Form 3160-5
(June 2019)UNITED STATES
DEPARTMENT OF THE INTERIOR
BUREAU OF LAND MANAGEMENTFORM APPROVED
OMB No. 1004-0137
Expires: October 31, 2021**SUNDRY NOTICES AND REPORTS ON WELLS**
Do not use this form for proposals to drill or to re-enter an abandoned well. Use Form 3160-3 (APD) for such proposals.

8. Well Name and No. STELLA BLUE 30 FED COM/710H

EOG respectfully requests an amendment to our approved APD for this well to reflect the following changes:

Revised Permit Information 10/24/2022:

Proposed Wellbore

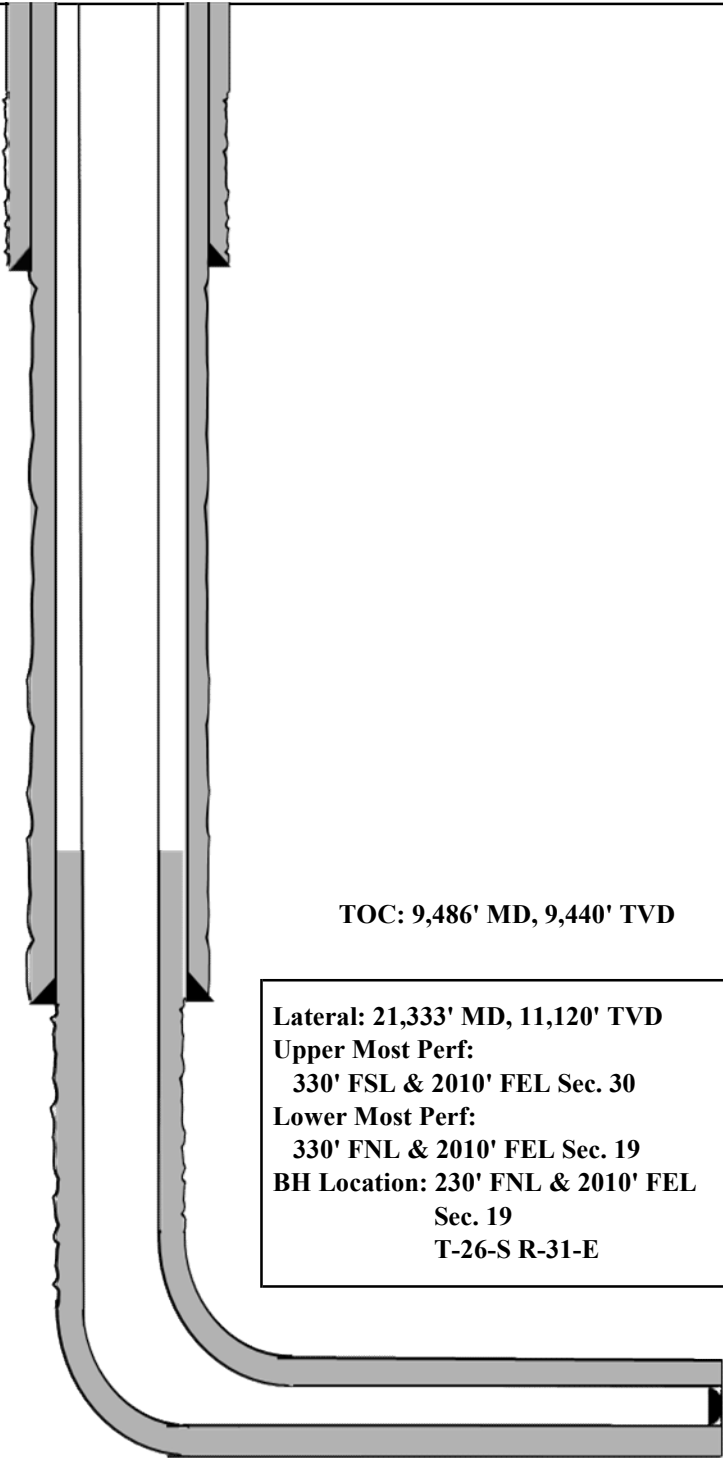
Design B**4. CASING PROGRAM**

Hole Size	Interval MD		Interval TVD		Csg OD	Weight	Grade	Conn
	From (ft)	To (ft)	From (ft)	To (ft)				
13"	0	1,114	0	1,110	10-3/4"	40.5#	J-55	STC
9-7/8"	0	9,986	0	9,940	8-3/4"	38.5#	P110-EC	SLIJ II NA
7-7/8"	0	21,333	0	11,120	6"	22.3#	P110-EC	DWC/C IS

Variance is requested to waive the centralizer requirements for the 8-3/4" casing in the 9-7/8" hole size. An expansion additive will be utilized, in the cement slurry, for the entire length of the 9-7/8" hole interval to maximize cement bond and zonal isolation.

Variance is also requested to waive any centralizer requirements for the 6" casing in the 7-7/8" hole size. An expansion additive will be utilized, in the cement slurry, for the entire length of the 7-7/8" hole interval to maximize cement bond and zonal isolation.

Variance is also requested to waive the annular clearance requirements for the 6" casing by 8-3/4" casing annulus to the proposed top of cement.
